# NEI White Papers on Crediting Portable Equipment in RI Decision Making (Comments from NRC)

NEI FRIDM Task Force  
March 16, 2016  
NRC Public Meeting at One White Flint

# **Streamlined Approach for Crediting Portable Equipment in RI Decision Making (Comments from NRC)**

## **Issue #4: Potential Negative Impacts Associated with Deep DC Load Shedding**

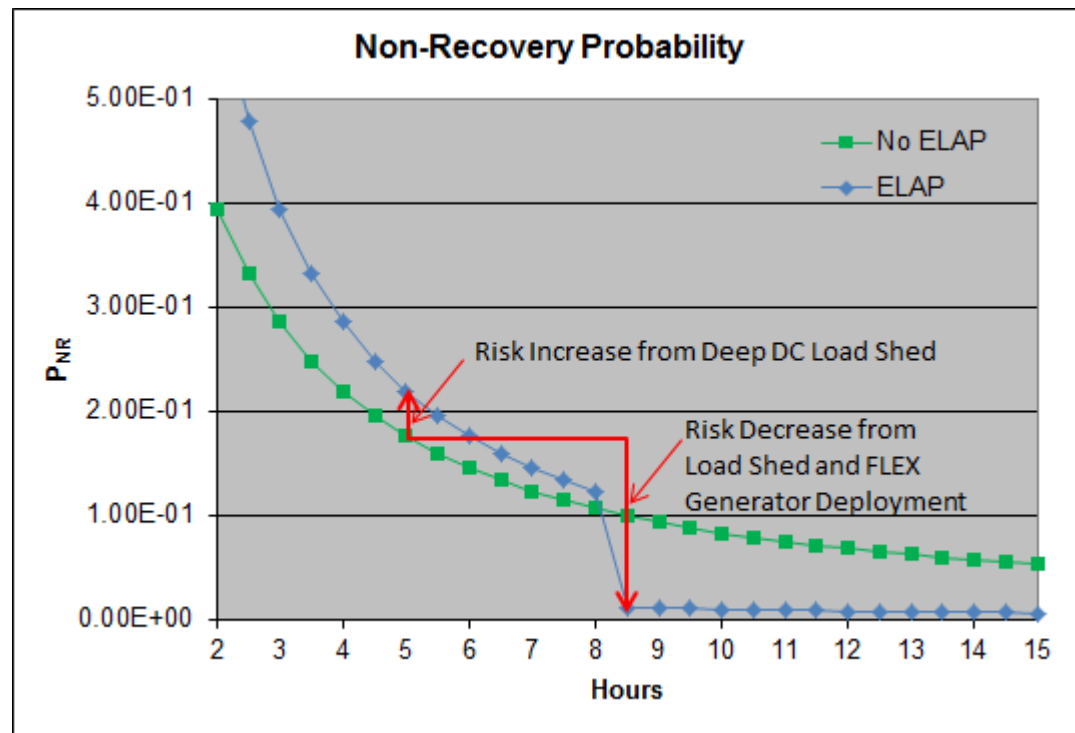
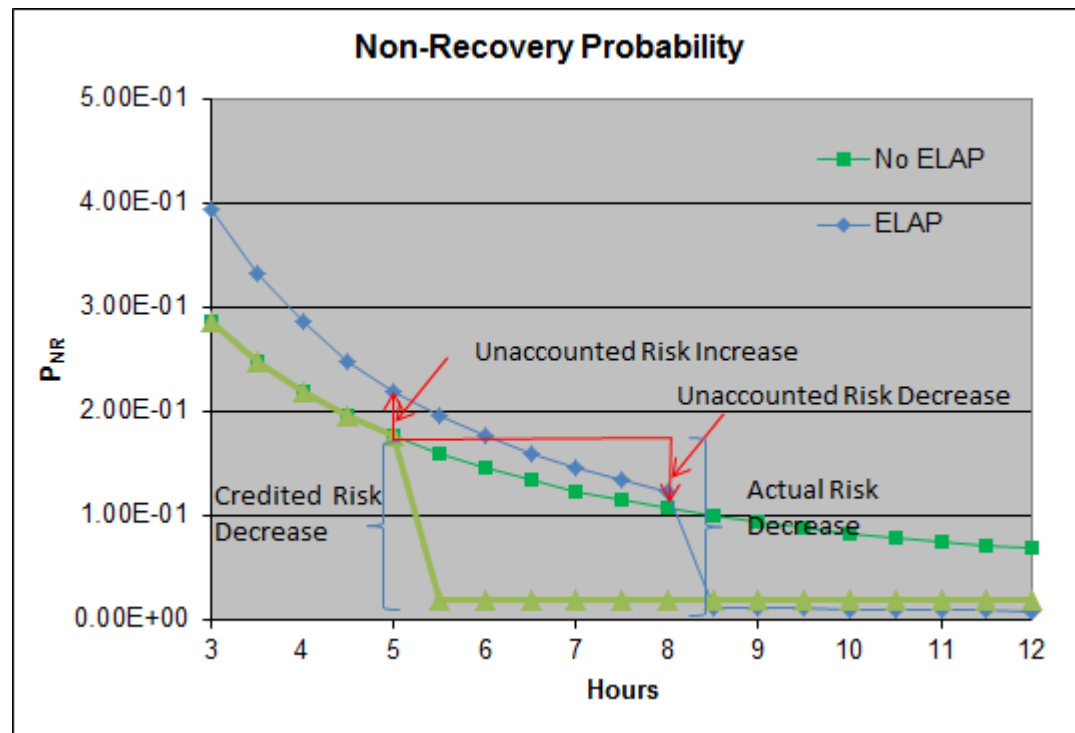
- If deep load shed fails and there is not sufficient time to establish portable generators, then the applicable SBO sequences will go to core damage (as before without credit for deep load shed)
- Major impact of deep load shed is on potential time required to restore off-site (or on-site) power
  - For example, if recovery of off site power takes 1 hour longer than normal with a deep load shed, non-recovery probabilities utilized in model may shift

- In the streamlined approach, the unaccounted for risk decrease should always be larger than the unaccounted for risk increase
  - Assumes extra time available from extended battery life is more than any extra time required to restore power if it becomes available
  - Exception would be if deep load shed precludes timely off-site or on-site power restoration
